## Royal Oak Roundabout Safety Improvements

**Road Safety Review  
Scheme/Preliminary Design**

May 2018

**Figure 3 Vicinity map showing wider network route options**

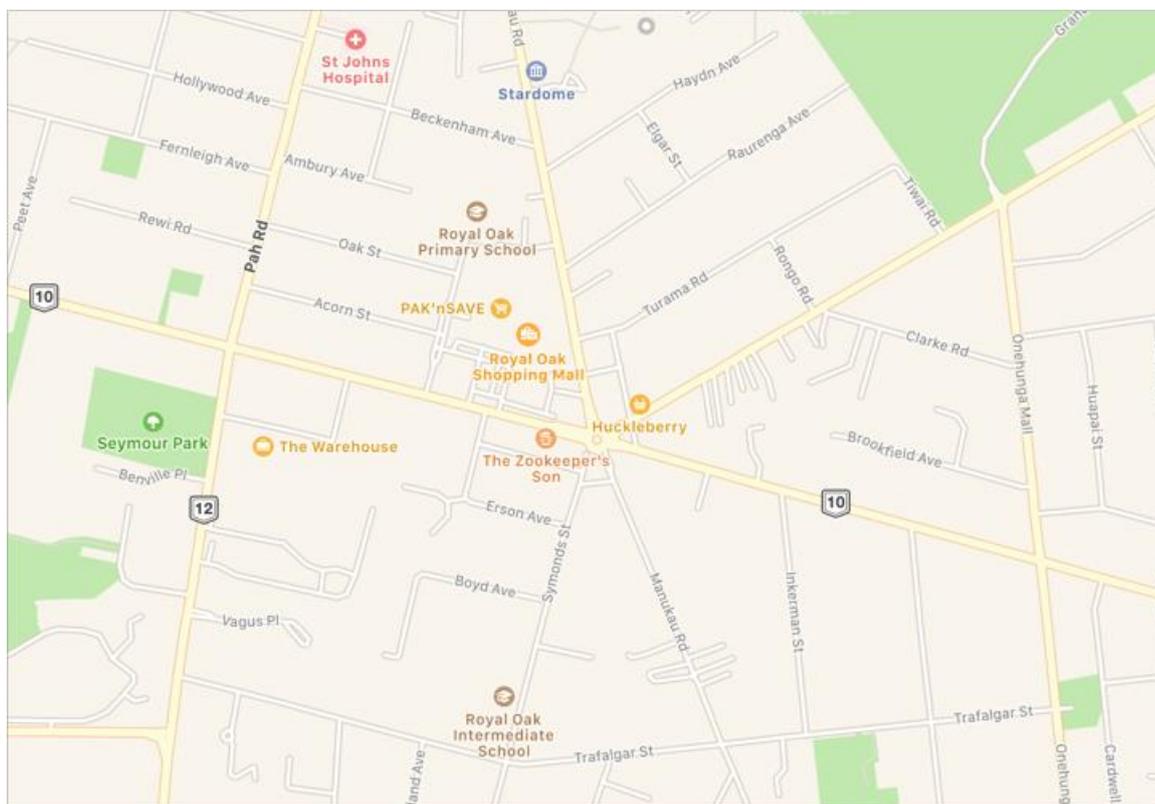
At a conceptual design stage, it is also appropriate to consider alternative forms of access or control and their relative safety performance. For example, other treatments could include reconfiguration to a signalised intersection, alternative roundabout configurations or alternative routes and way-finding measures to bypass this site and divert some traffic demand.

In the project briefing meeting it was mentioned that other central island shapes have been considered, as well as removing an exit lane on Mount Albert Road, a turbo-roundabout treatment with kerb-separated circulatory lanes, and staggering the pedestrian crossings. The possibility of a subsequent urban design study that included consideration of a raised shared space on Campbell Road leg with a driveway apron treatment at the roundabout was also discussed, as well as possible bypass alleys or streets.

Therefore, without further information the reviewer is reluctant to opine on whether the form and location of the roundabout is the best solution in terms of a safe system design for this specific location. However, in general terms, it should be noted that a well-designed multi-lane roundabout can provide an appropriate safe system design for an intersection.

*At an appropriate time, consider a project scoped to focus on urban design and the relative merits of alternative roundabout configurations and/or alternative network options and/or control, to improve safety performance.*

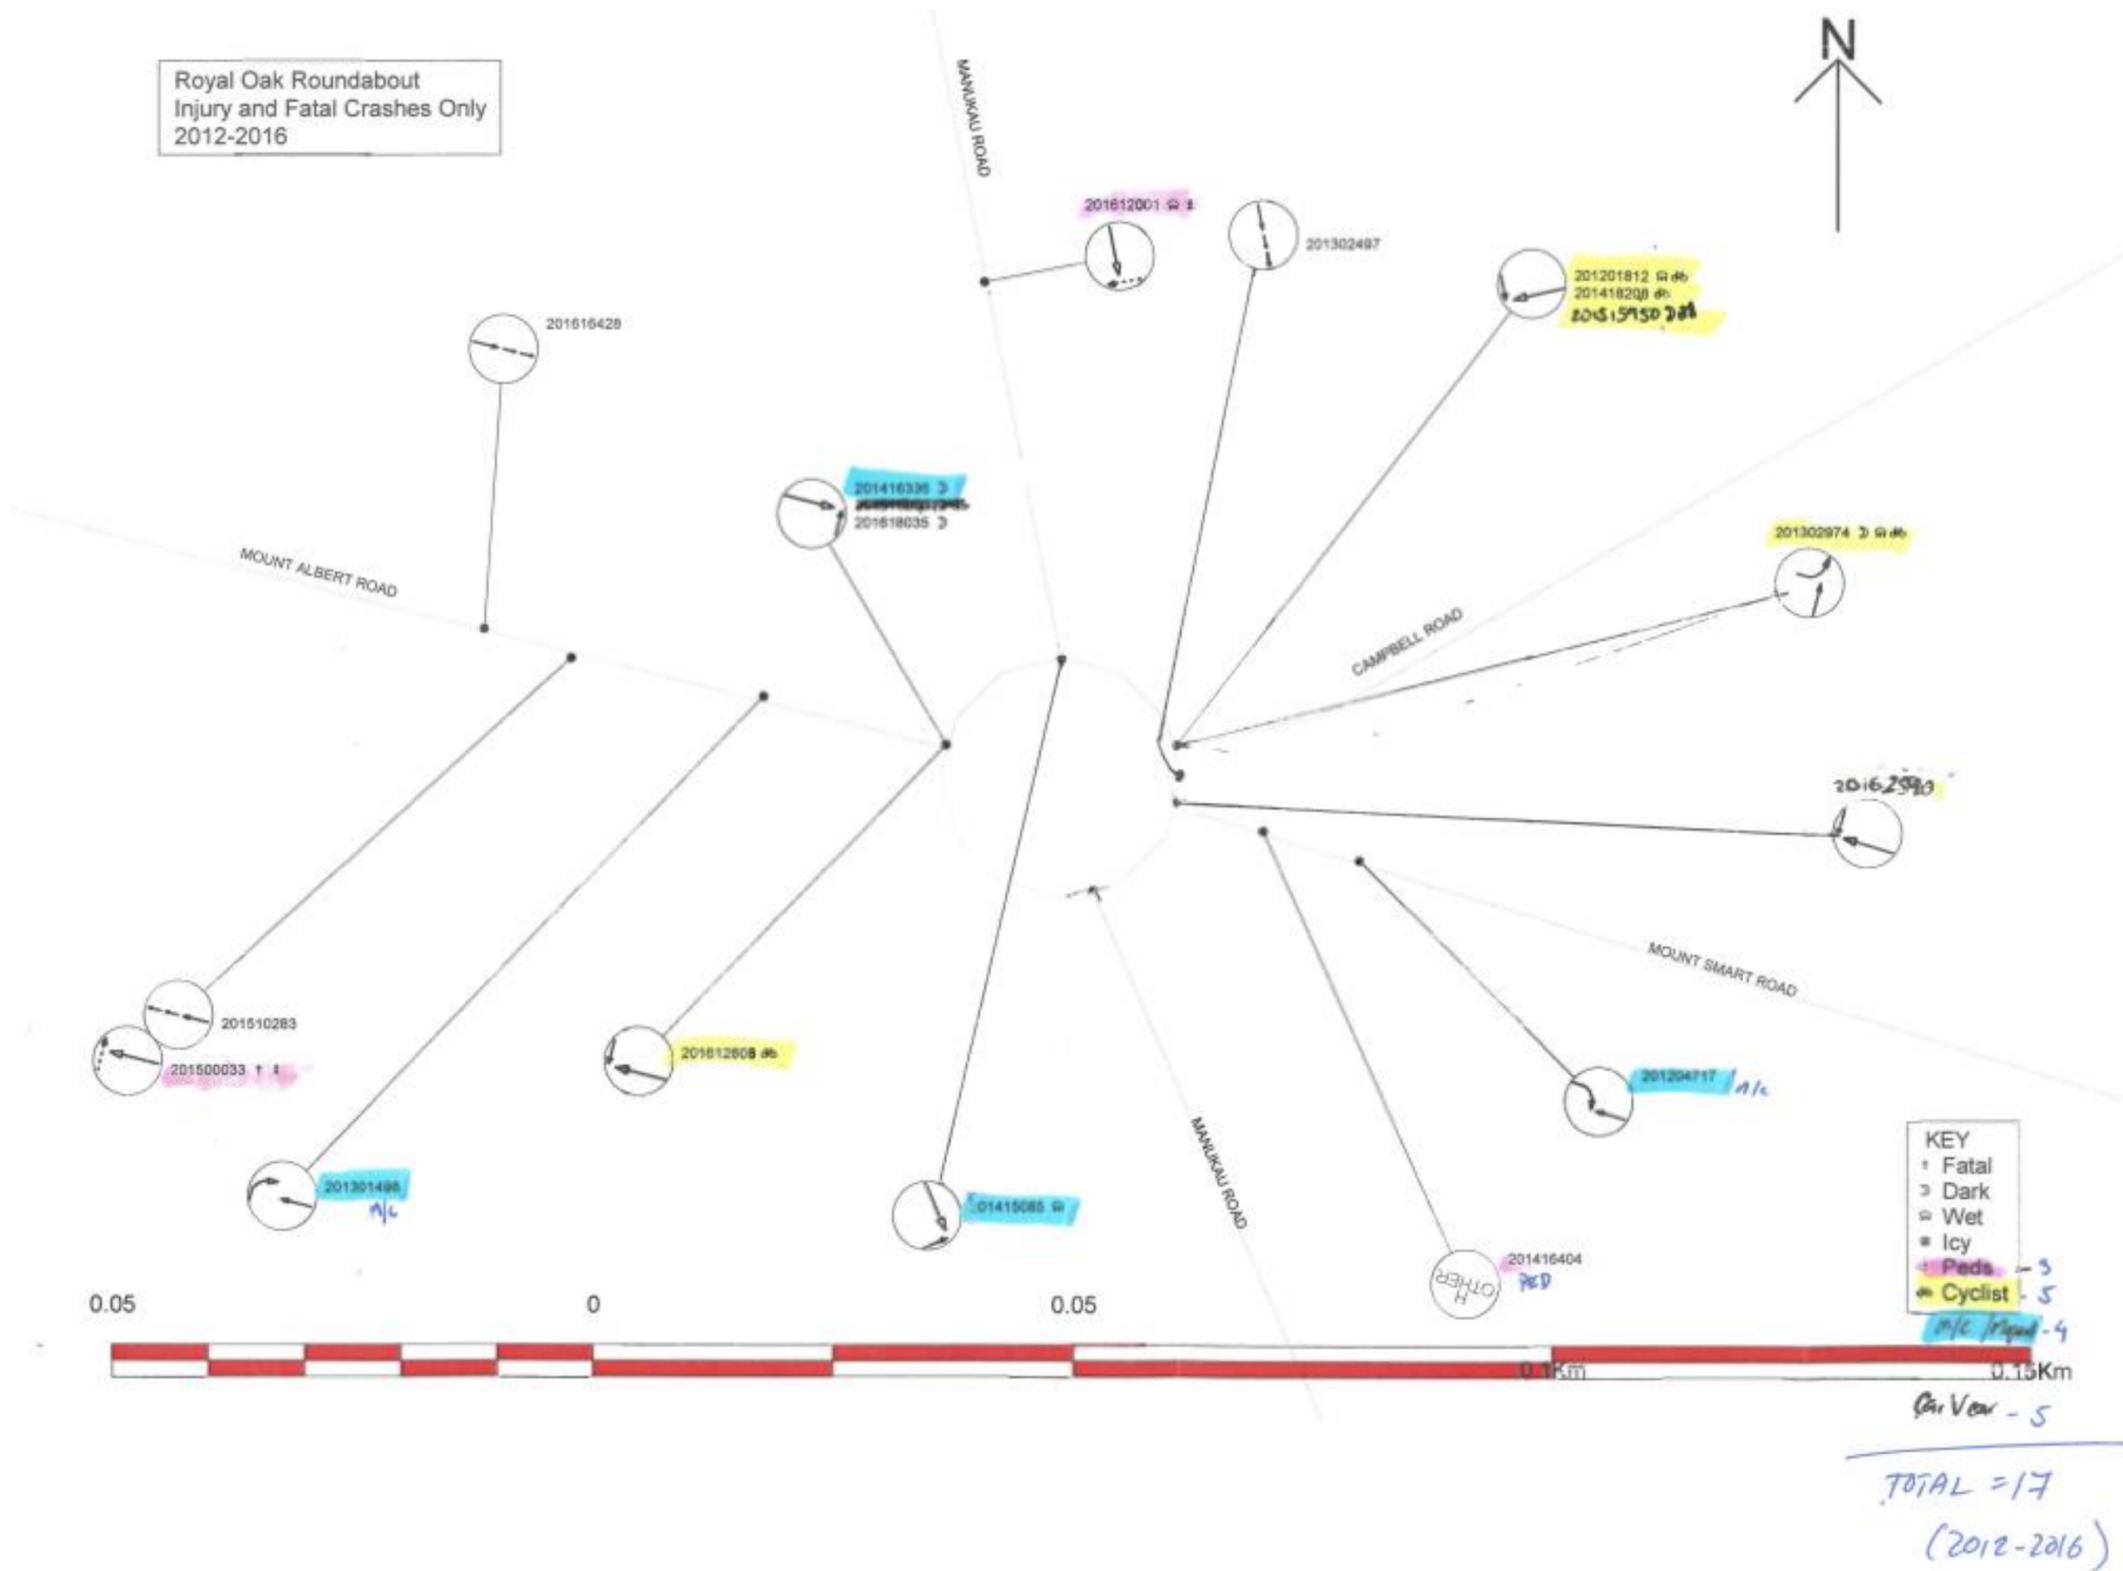
On the other hand, on multi-lane exits, perpendicular exits can cause exit path overlap, particularly for heavy vehicles. For example, the double lane exit to Mount Albert Road has a severe left turn on exit arrangement which adjacent trucks or buses are unable to negotiate without crossing the exit lane markings (see swept paths in Appendix B). This will lead to side-swipe conflicts and crashes.

- a) *At detailed design stage, assess the speed path profiles through the roundabout and provide for safe speeds: through both the entry and circulatory path, with the inner entry lanes being sufficiently offset from and as tangential to the central island as possible; to reduce path overlap for through traffic entering at Campbell Road and Mount Smart Road, and to reduce speeds on the tangential exit lanes at Campbell Road and Manukau Road south exit.*
- b) *Design the mountable central island apron kerb to be sufficiently offset from the fastest travel paths and flush with the pavement surface to minimise the tripping hazard for motorcyclists;*
- c) *Correct the geometry to avoid an exit lane path overlap conflict point for heavy vehicles at Mount Albert Road exit;*
